CALIFORNIA REGIONAL WATER QUALITY CONTROL BOARD - SAN DIEGO REGION

FACILITY INSPECTION DATA ENTRY FORM

Inspection Date: December 22, 2008

Inspection Date: December 22, 2008

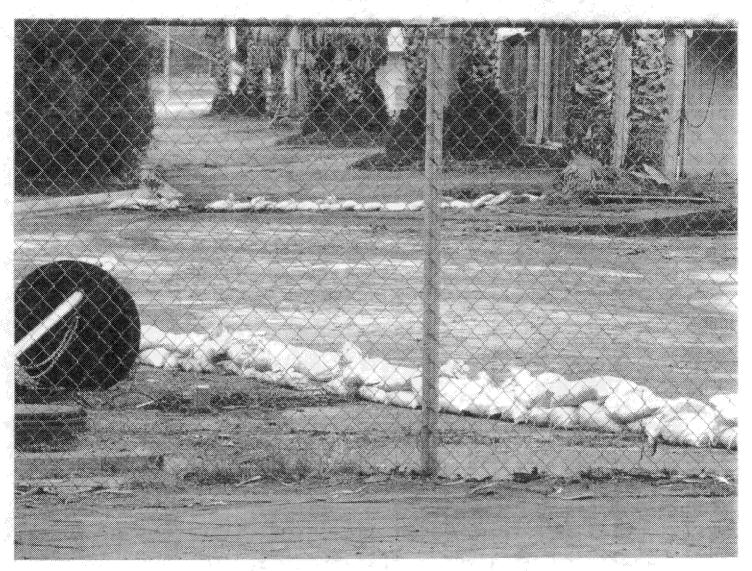
This is the same photo shown above at a closer range. The owners installed sand bags as temporary controls for runoff. According to the owners, these temporary measures will remain in place until the permanent best management practices or management measures can be installed.

Inspection Date: December 22, 2008

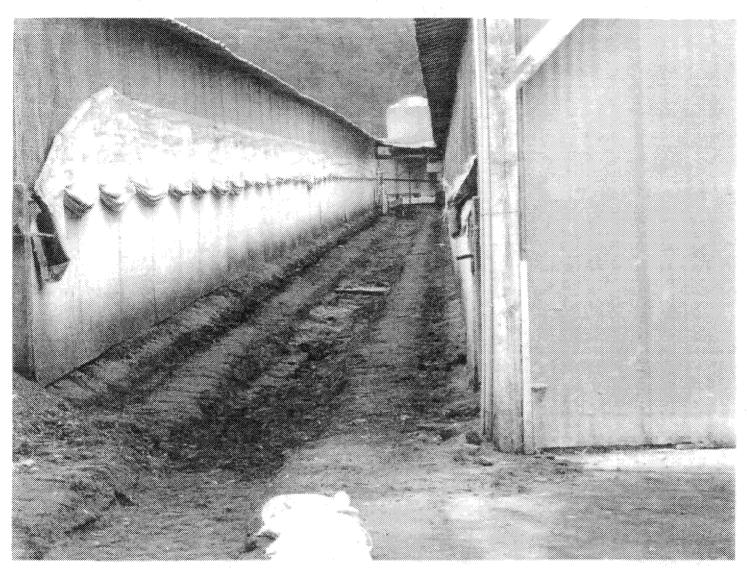
This photos depicts as earthen trench constructed by the owners to divert storm water and/or waste water back onto the site, and to prevent the illicit discharge of these waters from the site. Staff recommended the owners line the trench to help prevent sediment build-up, and to make this a more permanent management measure.
